Access Compliance Report

Public Rights-of-Way

(Curb Ramps)

Intersection ID: 31683	Main Street: GALLISON_AV	Cross Street: WILLIE_WORRELL_DR	Location: S
ADA ID: 459355E283D0	Ramp Type: PerpDiag	Initial Pass/Fail: Fail	Overall Compliance: No
Severity Score: 60			
Codes/Mitigation Info/Possible Solution		Field Measurements/Component Compliance

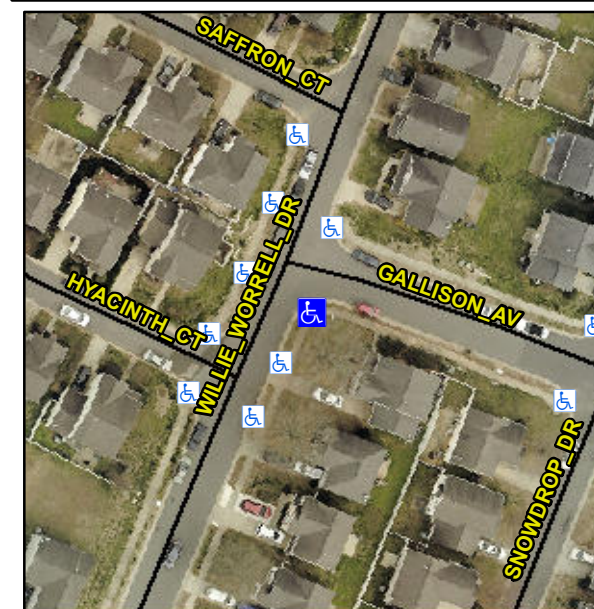
R304.5.1, R304.5.3

Compliance	Description	Data	Compliance	Description	Data
N/A	Ramp Length (in)	85.0	Yes	Ramp Slope (%)	5.5
No	Ramp Width (in)	26.0	No	Ramp XSlope (%)	11.4
N/A	Flare Type LT	N/A	N/A	Flare Type RT	N/A
N/A	Flare Slope LT (%)	N/A	N/A	Flare Slope RT (%)	N/A
N/A	Flare Traversable LT?	N/A	N/A	Flare Traversable RT?	N/A
N/A	Landing Length (in)	N/A	N/A	DWS Provided?	N/A
N/A	Landing Width (in)	N/A	N/A	DWS Contrast?	N/A
N/A	Landing Slope (%)	N/A	N/A	DWS Length (in)	N/A
N/A	Landing X Slope (%)	N/A	N/A	DWS Full Width?	N/A
N/A	Landing Curb? (Y/N)	N/A	N/A	DWS Offset (in)	N/A
N/A	Shared Landing?	N/A			
N/A	Gutter Ponding?	N/A	N/A	Gutter Slope (%)	N/A
N/A	Gutter Lip Ht (in)	N/A	N/A	Gutter X Slope (%)	N/A
N/A	Painted X Walk1?	No	N/A	Painted X Walk2?	No
	X Walk 1 Direction	To NE		X Walk 2 Direction	To NW
N/A	X Walk 1 Width (in)	N/A	N/A	X Walk 2 Width (in)	N/A
	X Walk 1 Slope (%)	0.0		X Walk 2 Slope (%)	6.3
	X Walk 1 X Slope (%)	4.0		X Walk 2 X Slope (%)	3.2

Remove & Replace Curb Ramp With Two New Directional Ramps or Equivalent.
